# Determination 2023/028

## Regarding the compliance of a pool barrier with section 162C of the Building Act 2004

56 Fairfield Road, Fairfield, Hamilton

Figure 1: The pool area (not to scale)

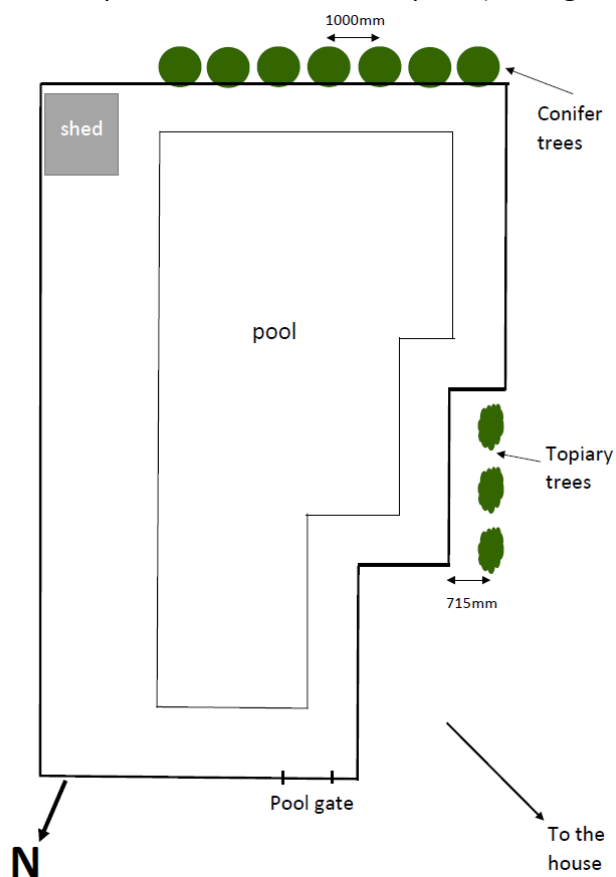
- 2.1. The owners' property is in a residential area in Hamilton. The house is located at the northwest end with the pool located towards the rear (south-east) of the property. The pool barrier consists of a metal fence on three sides, namely the southeast, southwest, and northwest side (the "pool barrier"). The remainder of the barrier is a timber paling boundary fence on the northeast side but the compliance of this section of pool barrier is not in dispute (see Figure 1).

**Figure 6: Applying the F9/AS1 assessment to the pool barrier (not to scale)**

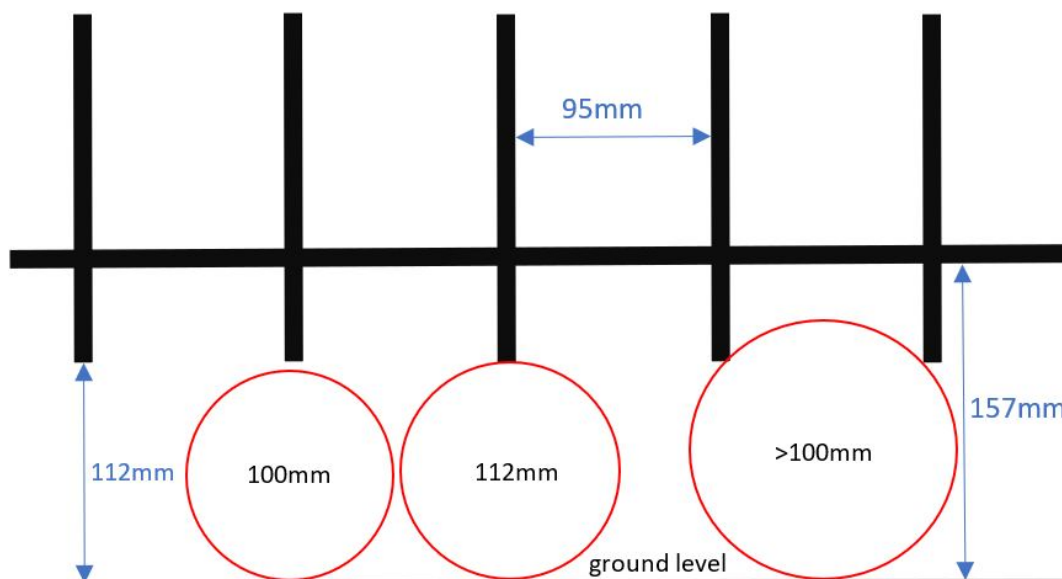
4.43.1. **F9/AS1 2.1.3** –The design of the pool barrier means that it could allow a sphere greater than 100mm to pass through (see Figure 6).
